# Gulfstream

This sheet transmits Revision A, dated December 20, 2010, to Gulfstream V Alert Customer Bulletin (ACB) 30, dated December 6, 2010, titled Fire Protection (ATA 26), Inspection – Third Engine Fire Bottle Installation.

NUMBER 30A

INSPECTION – THIRD ENGINE FIRE BOTTLE  
INSTALLATION

**Figure 1**

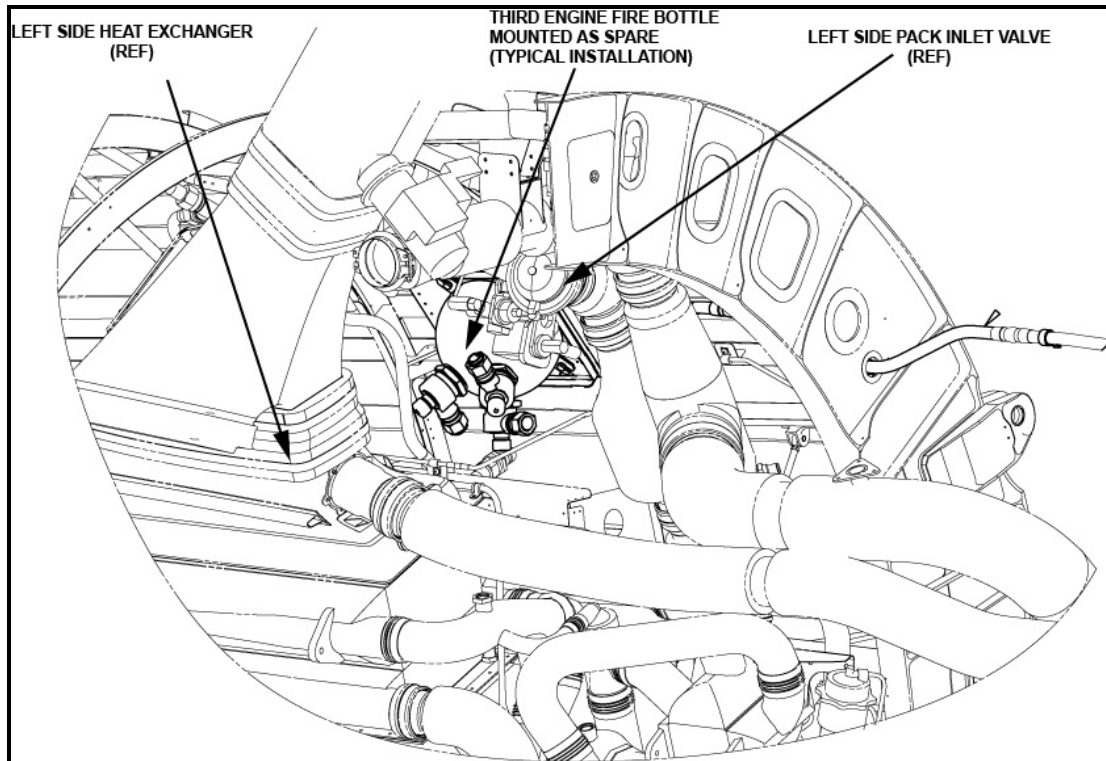
- A. Prepare the aircraft for safe maintenance. Refer to AMM, Safe Ground Maintenance Procedure, Chapter 20.
- B. Inspect aircraft to determine if a third engine fire bottle has been installed. This may be done by visual inspection (see figures 1 and 2) or by aircraft records review.

Third Engine Fire Bottle, Spare Mount Configuration (view looking outboard, left side)

**Figure 2**

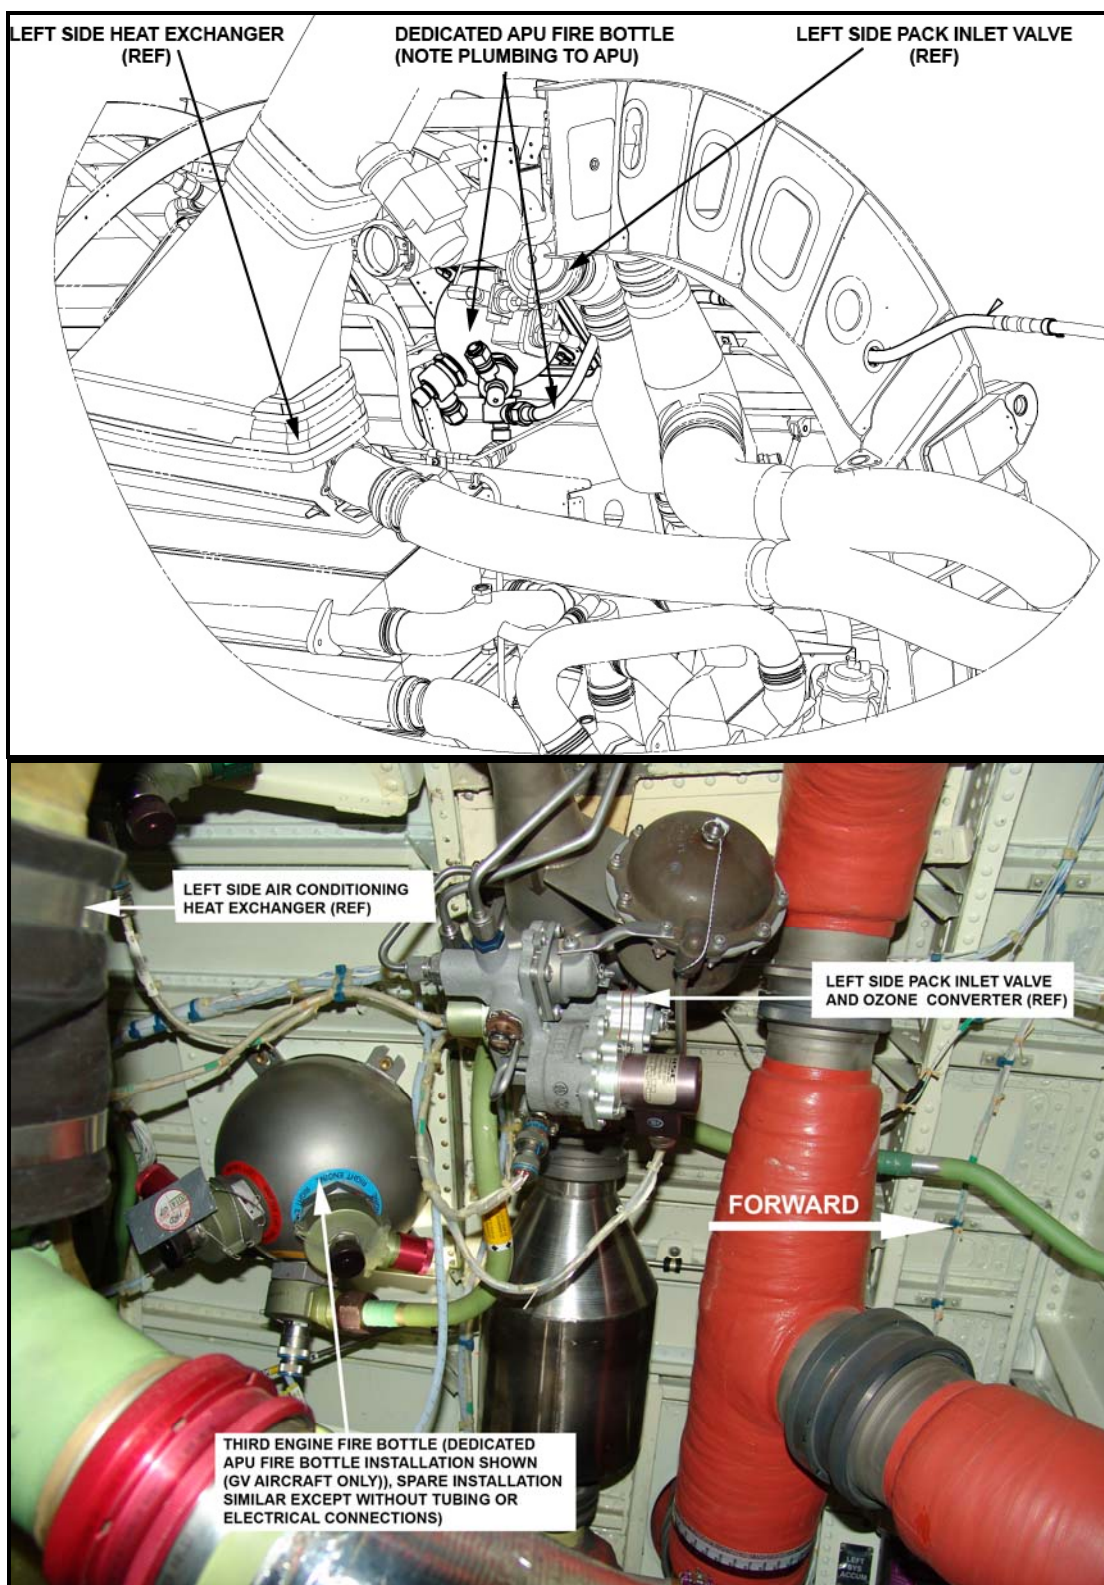
Third Engine Fire Bottle, Dedicated APU Fire Bottle (view looking outboard, left side)
